SUBJECT: Part 21 rept re radiator fan shaft bearing failure.

Subject: Potential 10CFR21 Finding  
Radiator Fan Shaft Bearing Failure  
Standby Diesel-Generators

COMPONENT - RADIATOR FAN SHAFT BEARING FAILURE

LOCATION - FLORIDA POWER & LIGHT COMPANY  
ST. LUCIE #2 NUCLEAR PLANT  
STANDBY DIESEL-GENERATORS

FAN BEARING DETAIL  
 Scale as 10180

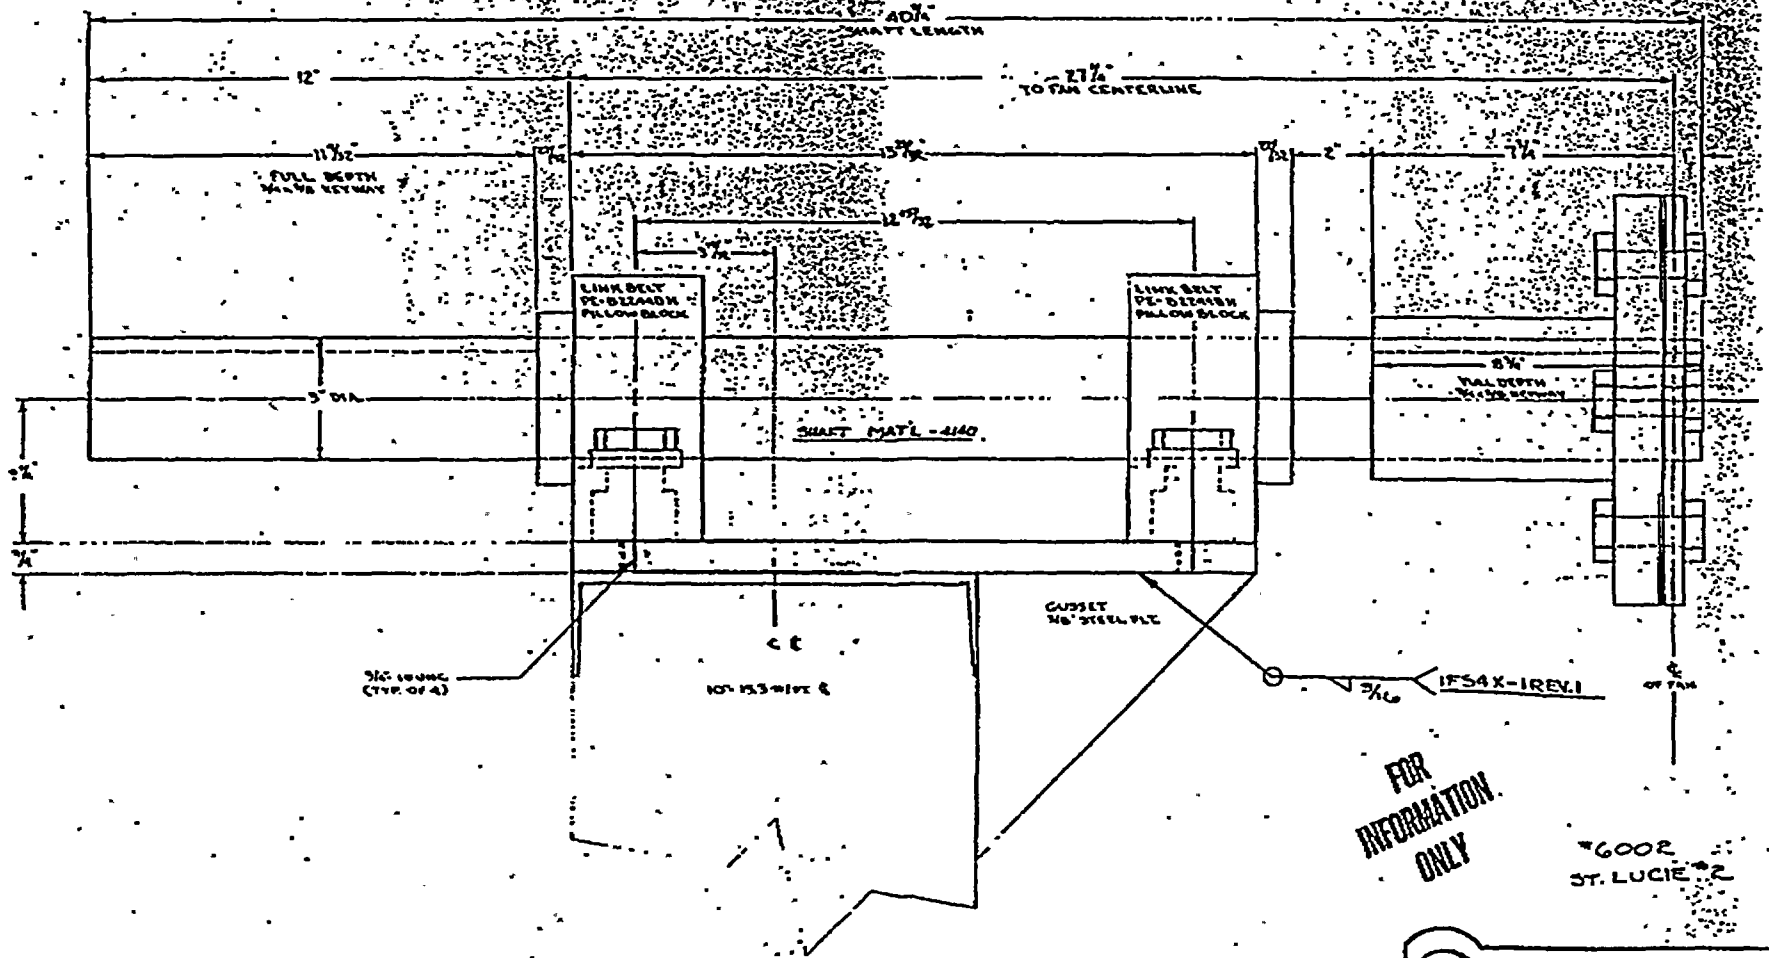
The radiator shaft bearings failed. Florida Power & Light Company analysis of the failure attributed the failure to loose bearing fit. A crack developed under the locking collar in the set screw area.

I believed the 3" diameter shaft was cold rolled turned stock with a tolerance of +.000 to -.004. If it was ground stock, the tolerance was +.000 -.002. The bearing PE-B22448 (3") requires a shaft tolerance of 3" +.000 to -.001. To get this a 3-1/8 round bar would have to be used then machined to 3.000+.000/-.001 diameter.

I note that the 27 1/4" dimension on drawings 10179 and 10180 should be 26 1/4" to the centerline of the fan. The 12" end dimension should be 13".

Since FP&L plans to order replacement shafts, we require verification of our findings or corrections you determine are correct. Attached is a sketch of the shaft as we see it.

DESCRIPTION: OEM DWG 10179 SH3 & 10180 SH3 SHEET NO. 6002 SK-1

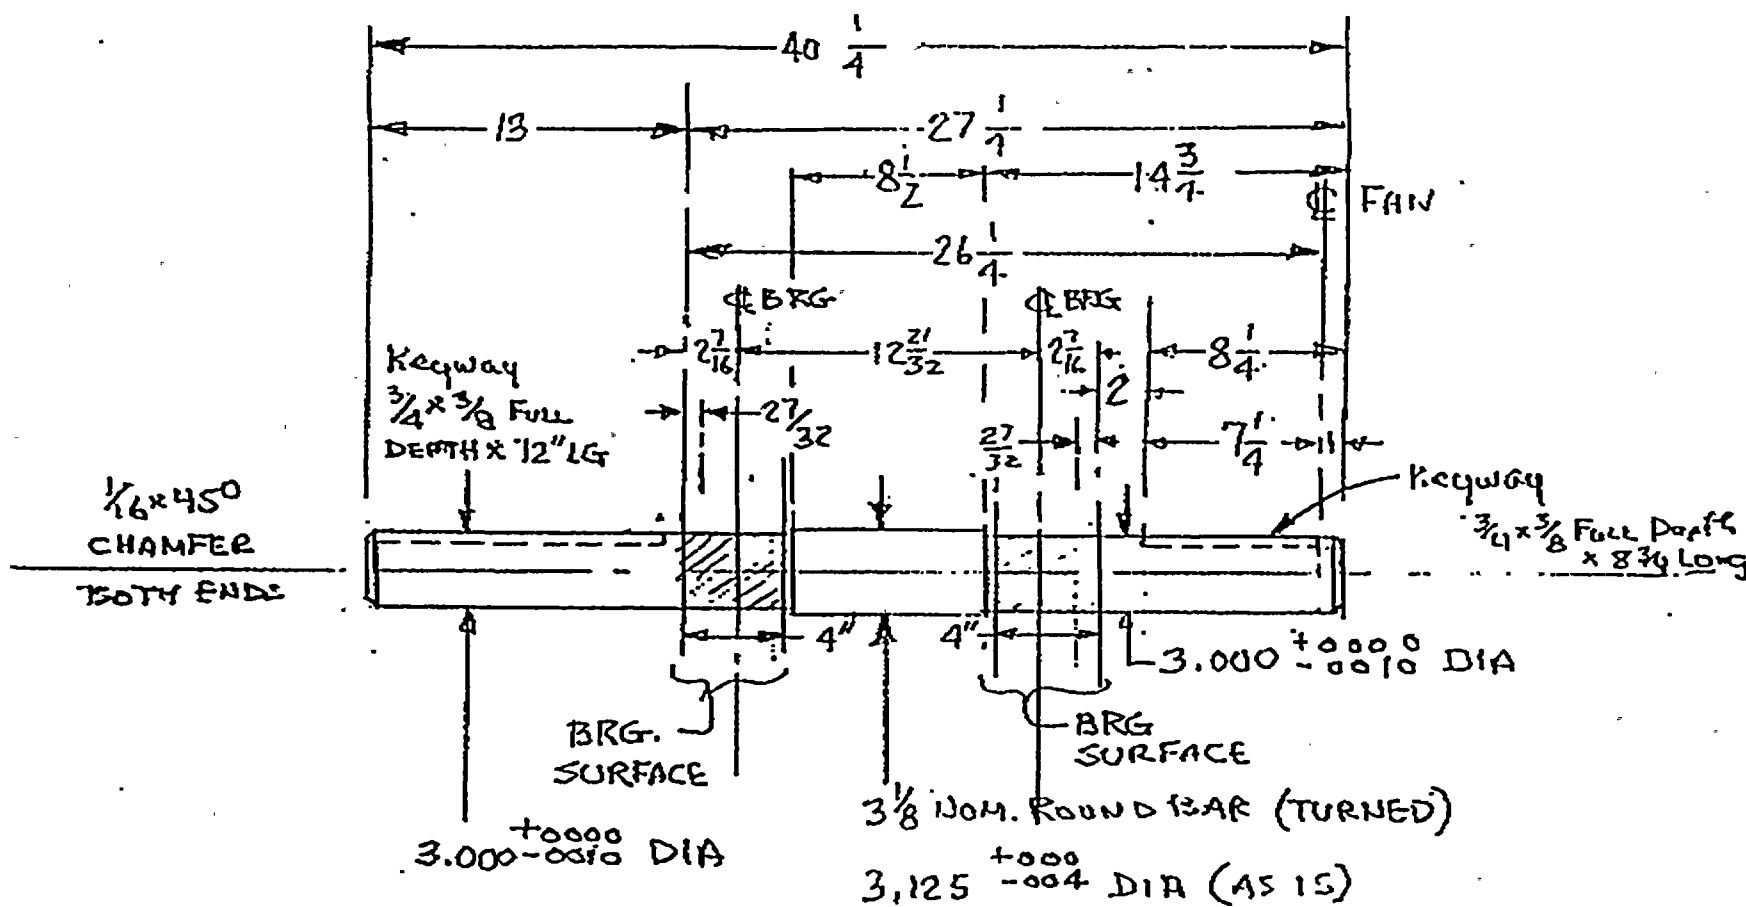
The radiator fan shaft was 3" round stock. I discussed this with Mr. Rich Rouner of the O & M Manufacturing Company who believed it was round stock (Turned). I found that 3" round stock (Turned) had a tolerance of +000/-004. The bearings used are Link-Belt Pillow Block P/N PE-B22448H. The shaft tolerance required for a 3" shaft is +.000/-.001. To meet this tolerance, 3-1/8" diameter round stock is required for machining to the proper tolerance. I have developed a sketch of the replacement shaft 6002SK-1.

MATERIAL  $3 \frac{1}{8}$  DIA ROUND  
BAR-TURNED  
COLD ROLLED  
SAE 4140
